**Proposed Community Facility, 682 Castlereagh Road, Agnes Bank, NSW (Lot 2 DP 252556)**

**Addendum Traffic and Parking Statement**

Title: Haveli, Castlereagh Road HRV turn in and out Garbage Truck	Scale: 1:250
	Date: 24/06/2020
Client: Haveli	Prepared: Henson Consulting
	Checked: CCH
	Dwg No: 0030

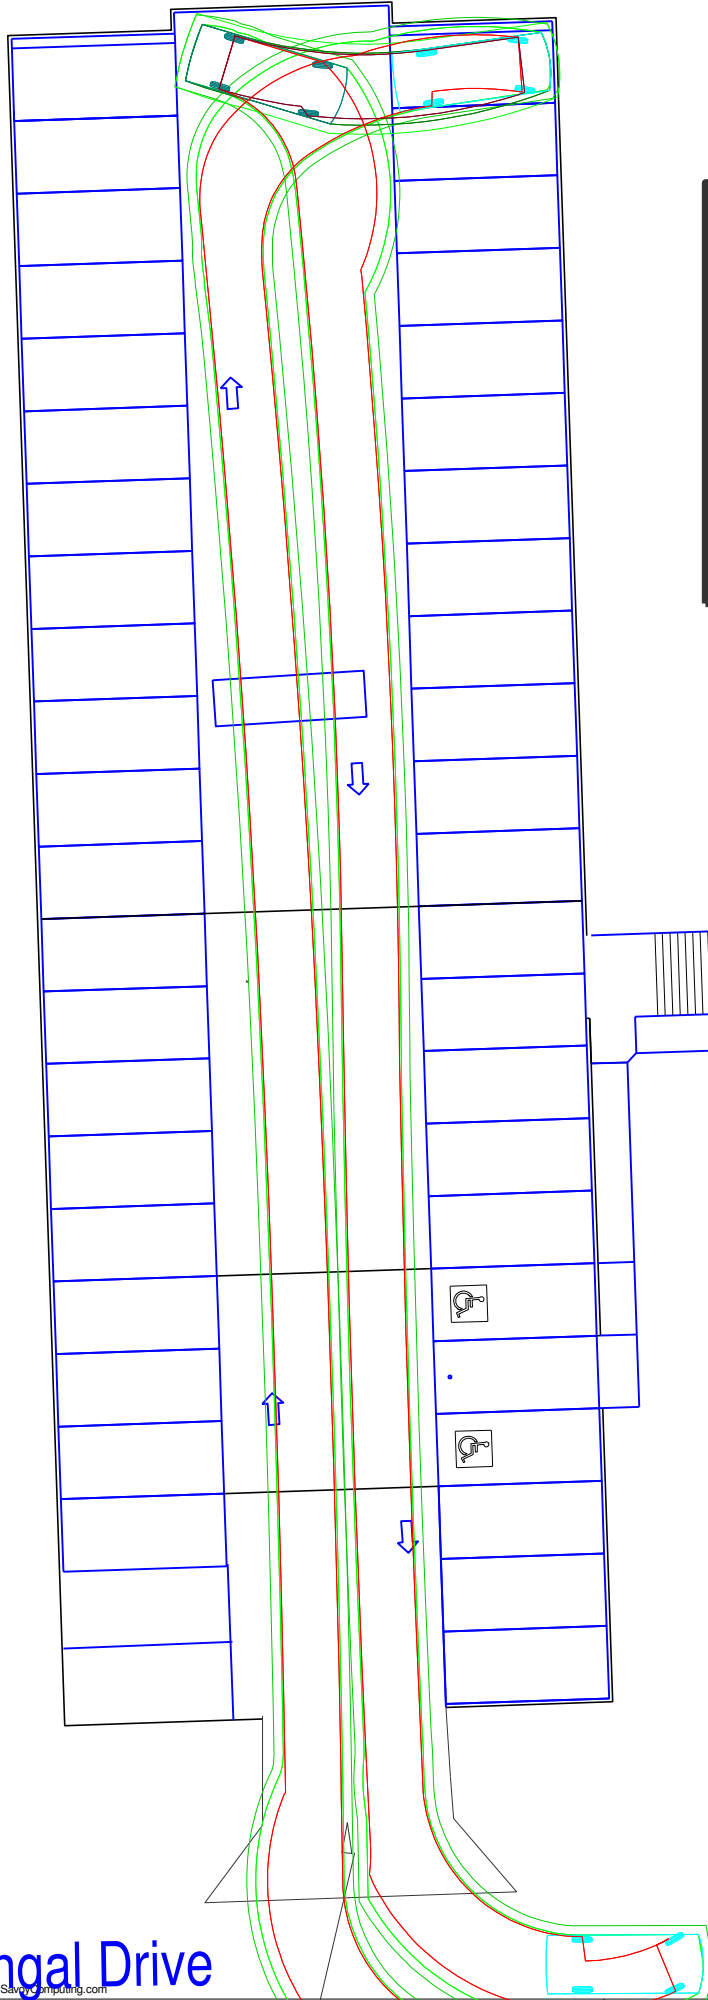
*6. Access and car parking locations, dimensions, car park, accessible parking, loading areas, turning swept paths for both cars, possible mini buses and waste collection vehicles and other service vehicles to enter and leave in a forward direction and to manoeuvre on site with desirably no service or medium heavy vehicle reversing or any unavoidable heavy vehicle reversing restricted to loading areas away from the car parking and public areas are requested to be addressed;*

Parking and loading areas have been designed in accordance with AS2890.1, AS2890.2, AS2890.3, and AS2890.6. Service vehicle or medium heavy vehicle visitation to the site will be infrequent, no separate service area is warranted, and some reversing within the car park area is considered acceptable. Examples demonstrating acceptable turning paths are appended to this Statement.

Notes:  
Swept turn paths for Medium Rigid Vehicle (MRV)/ Garbage Truck of 8.8m long,  
In accordance with AS2890.2, on a minimum turning path of 10m to the outside wheel.
